To: Saint Paul City Council  
From: George Gause, Heritage Preservation Supervisor  
Re: Appeal of HPC approval of ADU at 525 Holly

Re: Appeal on COA for an ADU at 525 Holly Ave

525 HOLLY PROPOSED

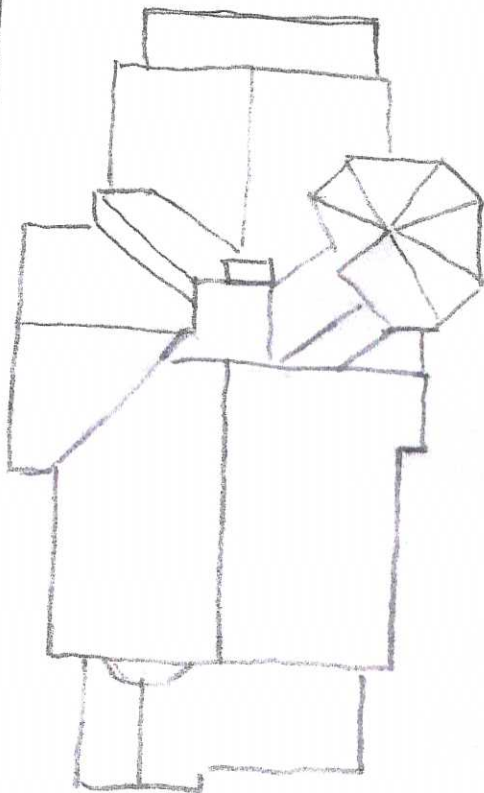
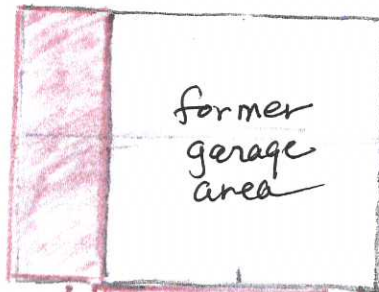
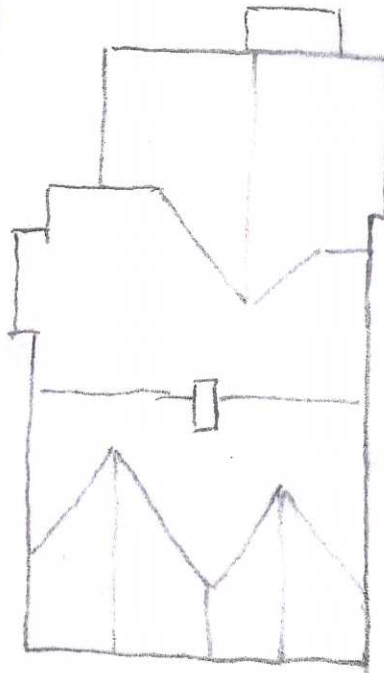
**Code Section 74.65b** Contrary to this new construction guideline, the ADU's design does not conform well to our adjacent back yard or to the neighborhood due to its **much greater relative scale compared to other neighboring structures**. Although the ADU is taller, but within the allowed height limit, it still has an impact. The increased wall height, in conjunction with the proposed 7 foot westward ADU extension toward the 529 property line and its fence, brings a taller wall within 3 feet of 529, creating a sense of enclosure and definitely affecting 529's back yard economic uses. Given that the ADU can be fully seen from Holly and there are 15 feet to the east for ADU extension, an eastward extension would diminish impact to important 529 back yard uses.

Pertaining to **Code Section 74.65b**, there was no mention or discussion that the proposed ADU's design totals an imposing 914 SF mass compared to the current structure's 576 SF. This is within the allowable SF back yard limit, but this 58.6% increase in 525's backyard physical infrastructure imposes on neighboring 529 Holly, which has three times less built structure in its backyard (see comparative illustration later).

**Code Section 74.65,e3c** provides guidance on the proposed ADU deck. The ADU deck is large (10x17), roofless, covers a 170 SF work out area, and protrudes from the ADU's south wall, all features that are totally uncharacteristic on a C. Johnston historic property or in the historic

district. In addition to being fully visible (image) from Holly Avenue half of the year, the deck lacks required visual refinement, a condition which was reinforced by HPC's recommendation that deck glass panels be replaced by cable railing, neither of which is historic.
